**Re: New Construction**  
**9101 Central Ave. NW**  
**Traffic Circulation Layout**  
Architect's Stamp 12-09-21 (K09D002)

Based upon the information provided in your submittal received 07-25-22, the above referenced plan cannot be approved for Building Permit until the following comments are addressed:

## Site Plan & Details

SP-102

**1 SITE DIMENSIONS PLAN**  
SCALE: 1/16" = 1'-0"

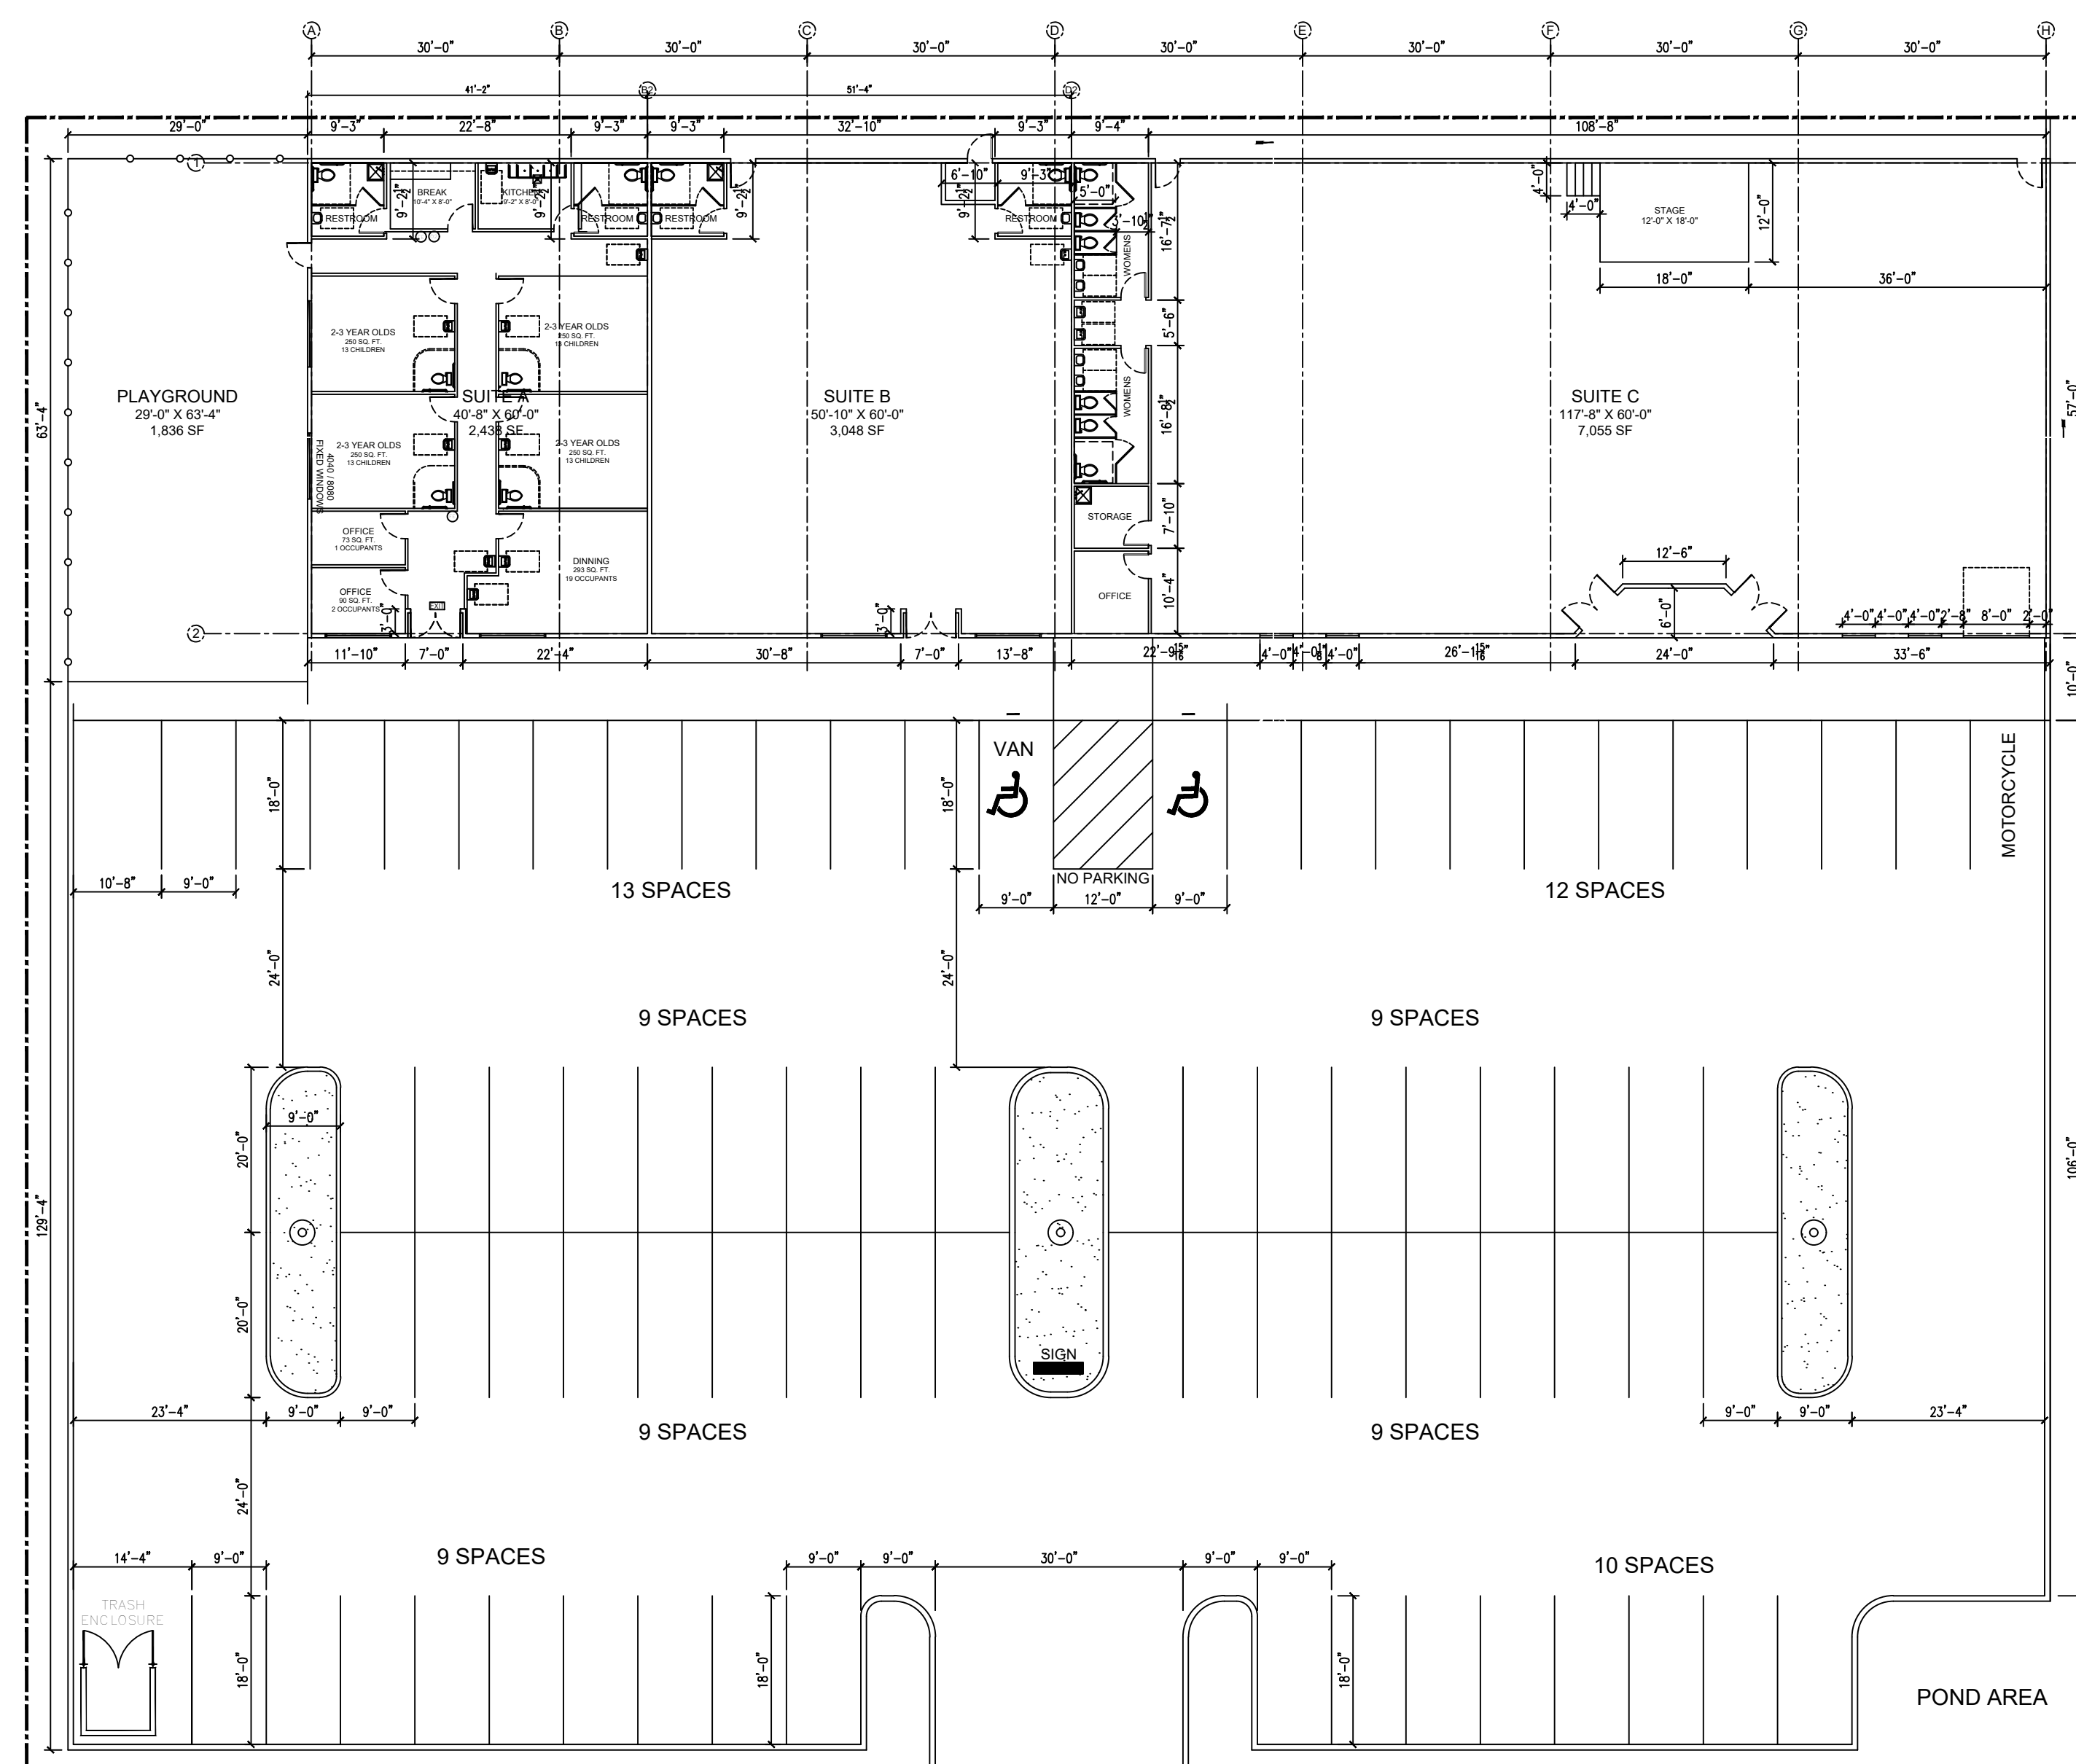
1. Please show a vicinity map showing the location of the development in relation to streets and well known landmarks.
2. List the number of parking spaces required by the IDO as well as the proposed number of parking spaces including bicycle and motorcycle parking.
3. Identify the right of way width, medians, curb cuts, and street widths on Central Ave NW.
4. Curb Return design is recommended for the driveway access off Central Ave.
5. Sidewalk and curb and gutter need to be build off Central Ave. from property line to property line. Reference COA std dwg 2430 & 2415A. For Sidewalk wavier please contact Ernest Armijo [earmijo@cabq.gov](mailto:earmijo@cabq.gov) at (505)-924-3991
6. What is the name of the proposed building?
7. Please list the width and length for all existing and proposed parking spaces. Some dimensions are not shown.
8. The minimum parking stall dimensions are:

16. List radii for all curves shown; for passenger vehicles. Radius for delivery trucks, fire trucks, etc. is 25 ft. or larger.
17. Per the IDO, a 6 ft. wide ADA accessible pedestrian pathway is required from the public sidewalk to the building entrances. Please clearly show this pathway and provide details.

18. Per DPM, a 6 ft. wide ADA accessible pedestrian pathway is required from the ADA parking stall access aisles to the building entrances. Please clearly show this pathway and provide details.

19. ADA accessible pedestrian pathway should not be placed behind parking space or adjacent to a vehicular way. Vehicle and pedestrian/wheel chair conflicts should be avoided as much as possible.

20. Please define the pathway, provide dimensions, show if there are any ramps, and provide ramps details.
21. Curbing should be installed to delineate landscape, parking, and pedestrian ways and identify points of access. Please call out detail and location of barrier curb.

22. Parking areas shall have barriers to prevent vehicles from extending over public sidewalk, public right-of-way, or abutting lots.
23. Refuse vehicle maneuvering shall be contained on-site. The refuse vehicle shall not back into the public right of way.; provide a copy of refuse approval.

3 SIGN DETAIL  
N.T.S.

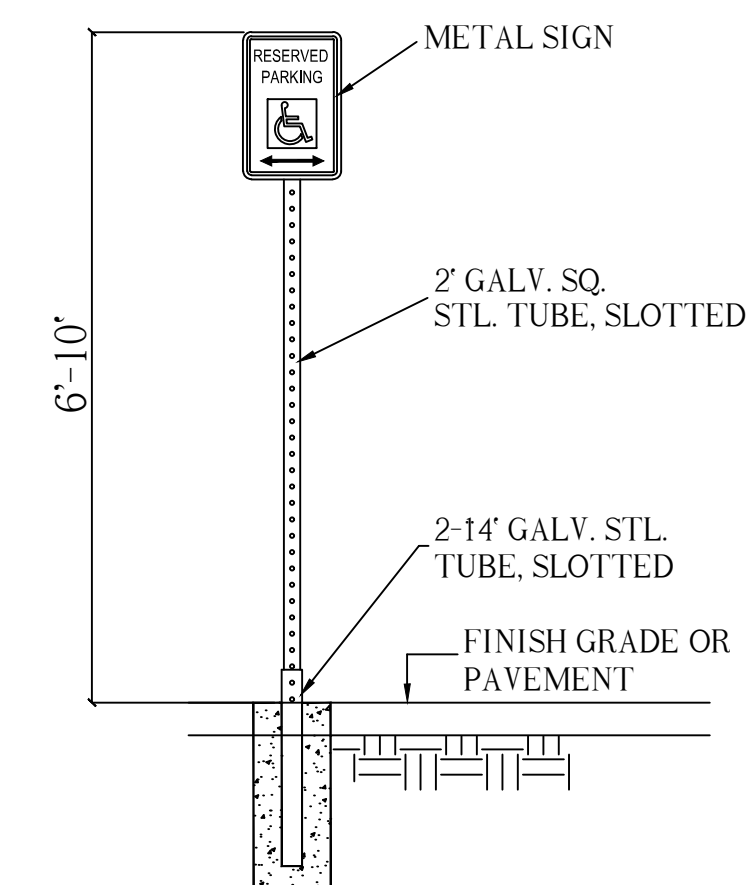
9. The ADA accessible parking sign must have the required language per 66-7-352.4C NMSA 1978 **"Violators Are Subject to a Fine and/or Towing."** Please call out detail and location of signs.
10. A 5 ft. keyway is required for dead-end parking aisles.
